Monitoring Report – Year 1
FINAL VERSION
Lake Wendell Mitigation Project
Calendar Year of Data Collection: 2018

NCDEQ DMS Project Identification # 97081
NCDEQ DMS Contract # 6826
Neuse River Basin (Cataloging Unit 03020201)
USACE Action ID Number: SAW-2016-00876
NCDEQ DWR Project # 2016-0385
Johnston County, NC
Contracted Under RFP # 16-006477

RE: WLS Responses to NCDEQ DMS Review Comments for Task 6 Draft Baseline Monitoring Report and Task 7 Draft Monitoring Report Year 1 for the Lake Wendell Mitigation Project, NCDEQ DMS Full-Delivery Project ID #97081, Contract #6826, Neuse River Basin, Cataloging Unit 03020201, Johnston County, NC

Project Name	Lake Wendell Mitigation Project
Project ID	97081
Reach ID	R3
Cross Section ID	X4
Field Crew	C. Manner, A. McIntyre

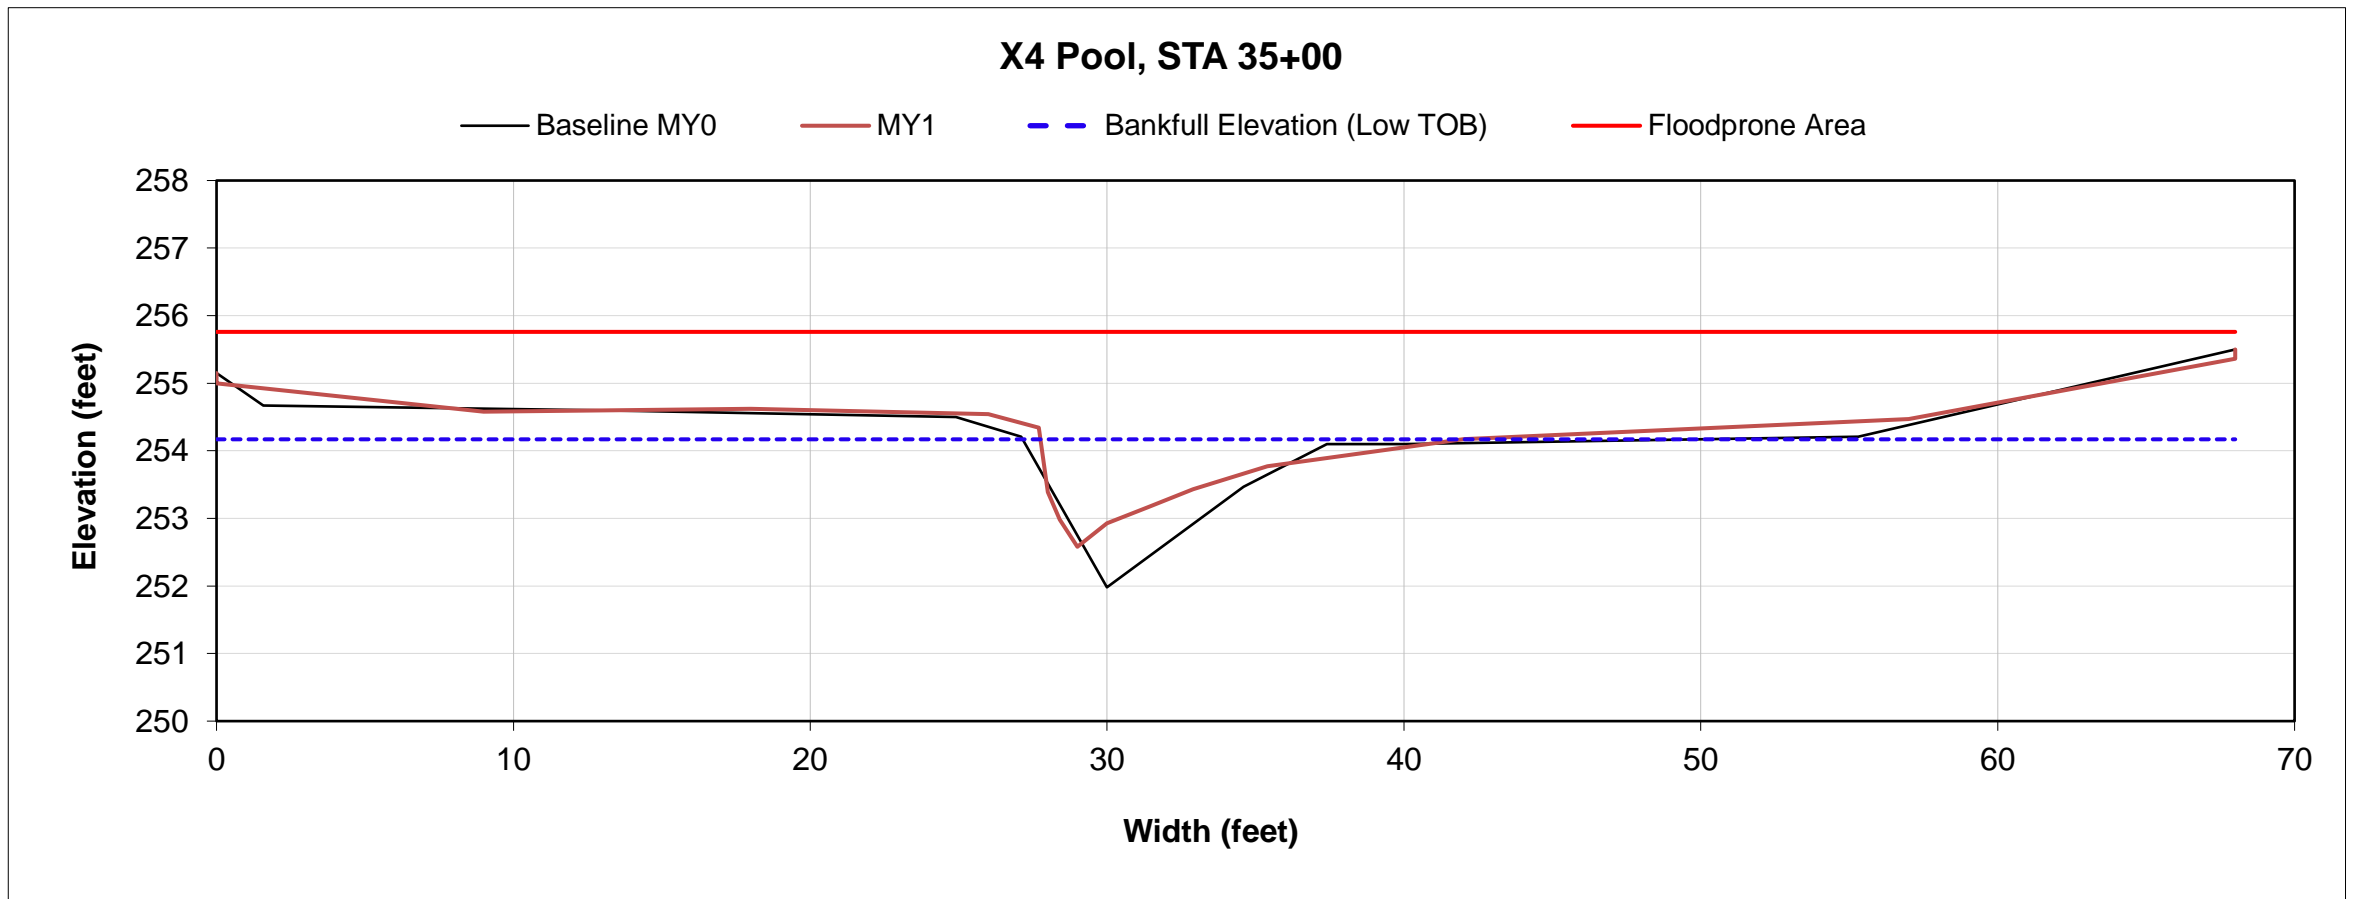
- 6. DMS Comment: Geomorph data: XS-4 (pool) looks like it has aggraded significantly from MY0 (I understand this is a small stream). Do you have any concerns about this? Shouldn't the BHR have updated based on this change with the new method?** WLS Response: WLS is not concerned about the adjustments to the referenced pool cross section, as it appears to be a minor channel adjustment towards the expected and desired stream dimension and stability. WLS used the new method for calculating adjusted BHRs. We have corrected/ adjusted the bankfull elevation change using the low TOB and as-built cross-sectional area. The result is less than one tenth elevation change and therefore the BHR is ~1.0.

Figure 4

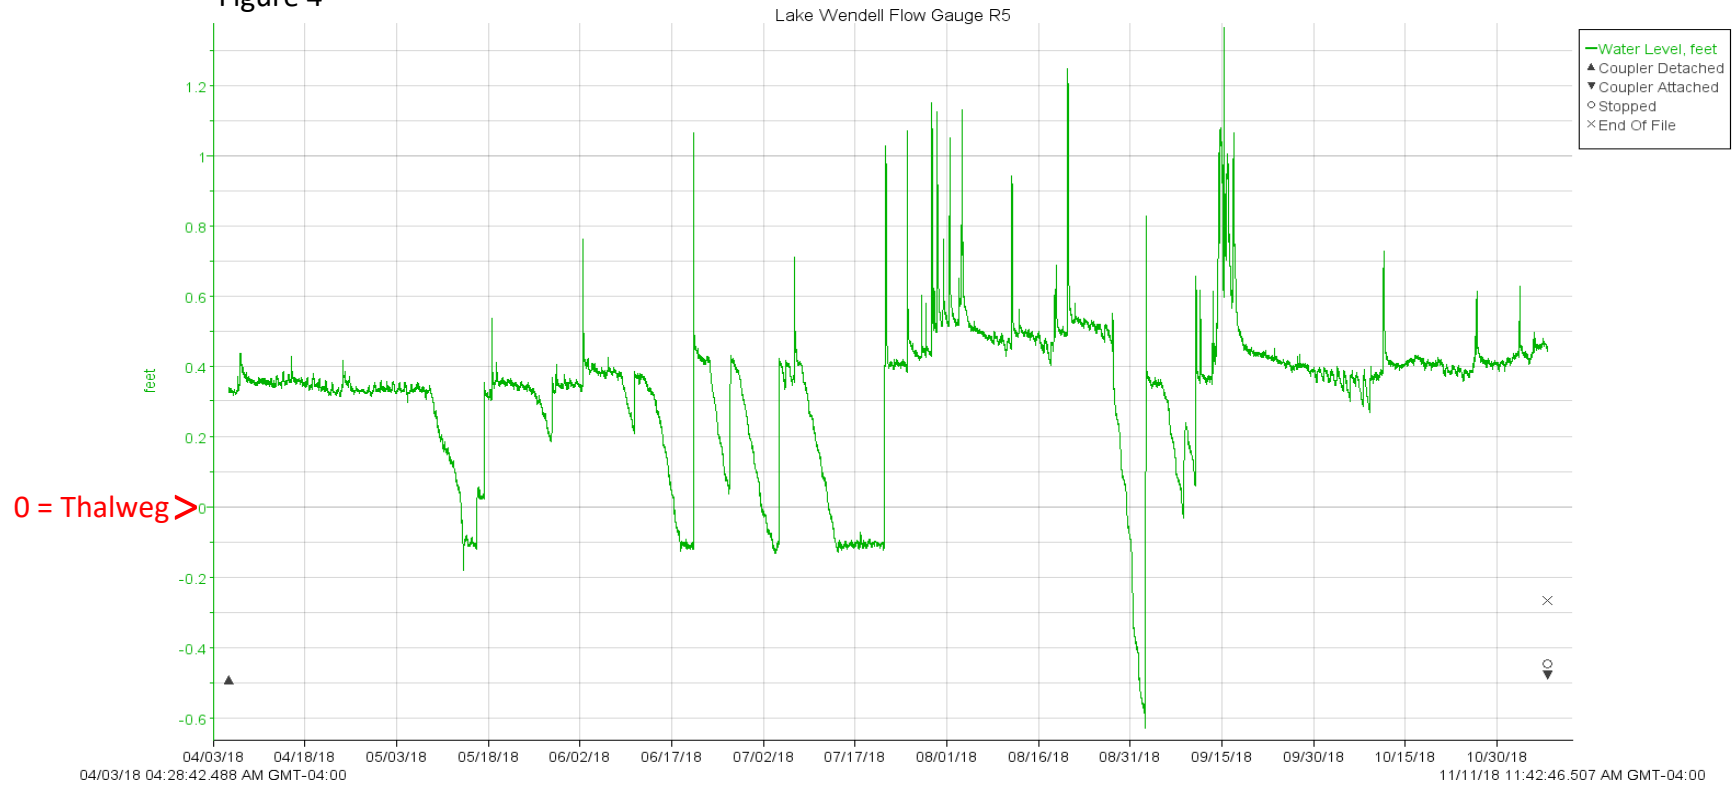
- 3. DMS Comment: Page 7, 5.4 flow, please reference the graph in the back (Figure 4). This figure should also be labeled in the back. Provide some information in the text on number of consecutive days of flow and/or show the number of days on the Figure.** WLS Response: The requested reference to Figure 4 Graph "Lake Wendell Flow Gauge" in the appendices has been added to Sub-section 5.4 Jurisdictional Stream Flow Documentation, as requested. Additionally, the referenced graph has been labeled, to include clearly illustrate the number of actual consecutive days of flow.
